CABINET MEMBER FOR ENVIRONMENT – 12 APRIL 2018

A420 AT BUCKLAND – PROPOSED BUS STOP CLEARWAYS

Report by Director for Infrastructure Delivery

Drawing No: 8140991/6401 Rev: C1

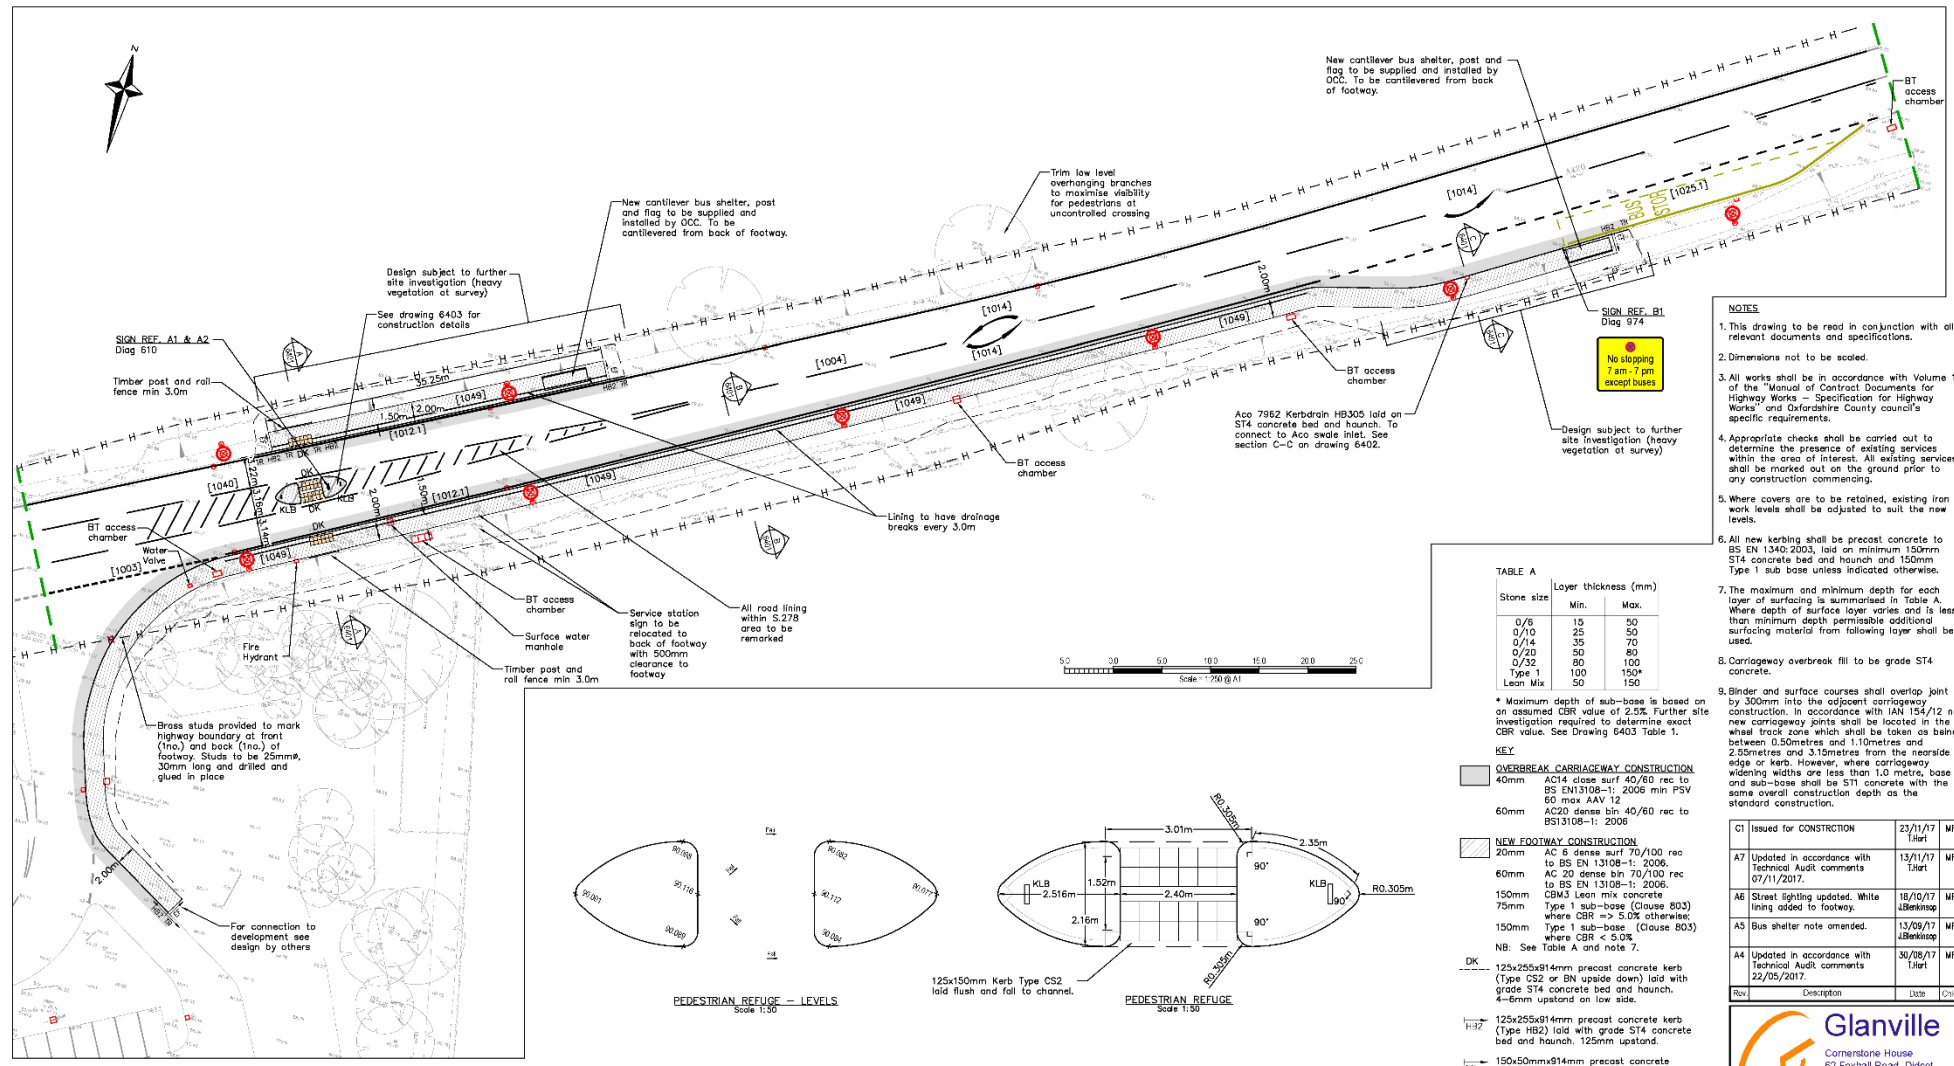
5. Thames Valley Police did not object to the proposal but raise some concerns and queries, which included the suggestion that providing a bus stop layby at the proposed stop on the north side of the road would be preferable (as is proposed for the new stop on the south side) and also that the proposed clearway within the layby (which is proposed to apply between 7am and 7pm) adequately catered for the anticipated use of the bus stop and would be of sufficient length to ensure that buses could pull back onto the A420 safely should a vehicle be parked in the layby in front of the bus stop.
6. The above concerns are noted although it is not considered viable to provide a bus stop layby on the north side of the road taking account of the costs and that land acquisition may well be required. It is, however, agreed that it would

7. County Councillor Heathcoat, the local member, while not expressing an objection to the proposal, noted that the A420 had a poor accident record and with increasing traffic volumes, the introduction of further bus stops could lead to potentially more hazards. Her main concern, however, was that the proposals did not include the provision of a continuous footway between the development and Buckland village, noting that the development would likely provide an employment opportunity for local residents (in particular young people) and also that residents may wish to use the retail store within the development. A further concern was that the proposed new pedestrian refuge required a good standard of lighting to ensure road safety, but equally that that should be designed to minimise light pollution.

11. Pusey Parish Meeting objected to the proposals on the grounds of road safety and traffic delays, the likely limited use of the stops and the preference for a footway linking the site to Buckland and the existing bus stops at the Buckland turn.

RESPONDENT	SUMMARISED COMMENTS
(1) Traffic Management Officer, (Thames Valley Police)	<p>Concerns - It is impossible to agree this proposal in the absence of what is proposed for the north side of this road . Dependant on where the Bus Stop is proposed I fear conflict with the new crossing point. Might I suggest an off road lay - by is considered the safest option for the north side as well. The layby restriction is timed, does this coincide with future bus time table? Should large goods vehicles park forward of the new Bus Stop Clearway ,will a Bus still be able to exit safely.</p>

(3) Local County Councillor, (Faringdon Division)	<p>Concerns - I wish to ensure that if these bus stops are to be installed that, as much consideration as possible is given to pedestrian safety and traffic safety – the A420 is notorious for its accident history especially in this area in my Division.</p> <ul style="list-style-type: none"> • Traffic is ever increasing travelling both east and west with the housing development taking place both in my Division and in the Swindon area. • Traffic weight is increasing too – commercial traffic/transporters all types of HGV's and farm vehicles. For a bus to make an entry into this traffic flow is getting increasingly more difficult – I see and experience these difficulties travelling the A420 daily. Having an additional bus “pull-in” with cause further traffic difficulties. • There are of course already 4 bus stops servicing this area both on the eastward and the westward bound journey of the A420 – 2 situated at or near the Buckland/Gainfield junction and then further along at Pusey Furze. • I would like the footpath that is being proposed just by the 2 new bus stops to be extended up to the existing

<p>bus stops at the Buckland junction on both sides of the road – this will ensure that those alighting from the bus are safe traversing to work from each of the bus stops to the travel lodge and equally, and most importantly the local community can walk to their employment from the village of Buckland in complete safety too. There will be local employment (young people from the village will be drawn to working at this development) and there will be pedestrian traffic to the M&S shop for groceries and the daily paper. Currently there is no safe way for people to undertake this route.</p> <ul style="list-style-type: none"> • The proposed new pedestrian safe haven MUST be well lighted to ensure safety to those crossing the road as traffic is travelling at a minimum speed of 50mph and many break the statutory speed on the A420. However, care must be taken to ensure there is no light pollution to the inhabitants of the village who have no street lighting. • If there is no way that the footpath can be extended as I would like then the preference for me is that with this development there must be benefit to the local community of Buckland and I would confirm that an extended footpath from the already existing bus stops at the Buckland/Gainfield junction are installed.

<p>(4) Vale of White Horse District Council</p>	<p>No objection.</p>
<p>(5) Pusey Parish Meeting</p>	<p>Object – In summary:</p> <ul style="list-style-type: none"> • Pusey will not benefit, and may even be disadvantaged (see below), by the new bus stops. • There is no Little Chef, so why is this being pursued. • There is no footpath to the stops, except from the site of the new motel. How will people get to and from the stops? And if they do go there for the buses, will they be able to park at the motel without using it? • Any bus stopping on the East going side will create a blockage on the A420, which can be congested anyway, and the pedestrian refuge is a further obstruction near a junction – is that sensible? • There are bus stops about 500m West, at the Buckland junction. These must remain, as the best site to serve Buckland. So will buses stop at the new ones as well? • A stop on the North side would encourage pedestrians to cross the road where there is no pavement or path to anywhere else, which is dangerous anyway. • There are footpaths that come to the A420 from Buckland and Pusey, 200 m West of the motel site. It would be far more sensible to make a safer crossing point there, and a pavement along the road between the Buckland crossroads and the motel/filling station, if there is money to be spent. <p>All in all, this appears to be a project that dates from a time when the Little Chef was there, and is now out of date. Why has it not taken account of the changed circumstances? Is it that there is money to be spent in the programme, and it has a momentum that cannot be stopped?</p> <p>Are the proposed bus stops to enable staff to get to and from the site? If so, this seems exceptional, and possibly unjustified. It would reinforce the view that a pavement from the existing Buckland stops along the South side of the</p>

be advisable to extend the hours of operation of the bus stop clearway to apply between 6am and midnight, and also to extend the clearway marking to the west to address the concern that buses may be impeded when exiting the layby by other vehicles parked to the west of the bus stop within the layby.

8. It is accepted that the new bus stops and refuge will introduce new potential conflicts but also it should be noted that the existing bus stops on the A420 thankfully have a very good safety record and there is no reason to expect that the safety performance of the proposed new stops will be any different. It is confirmed that lighting will be provided for the refuge and that equipment will be designed to provide adequate illumination while also minimising light pollution.

9. It is agreed that in principle the provision of a footway linking the development to the Buckland turn would be desirable for the reasons mentioned by Councillor Heathcoat but, unfortunately, it is not considered possible to require the developer to fund that provision given that planning consent was given on the basis of the current proposals. Opportunities for funding this provision will be explored but it is currently unclear as to whether there is a realistic prospect of this being progressed at least in the short to medium term.

12. While the above concerns are noted, provision of bus stops close to the development site is considered to be required to facilitate journeys by staff in particular to and from the development, given that the existing bus stops by the Buckland turn are around 500 metres to the east. As discussed above, the existing bus stops on the A420 operate with good levels of safety and without causing any appreciable delays to traffic and, while it is agreed that a footway

link would be desirable in principle, it is not considered viable to progress this in the context of the current development.
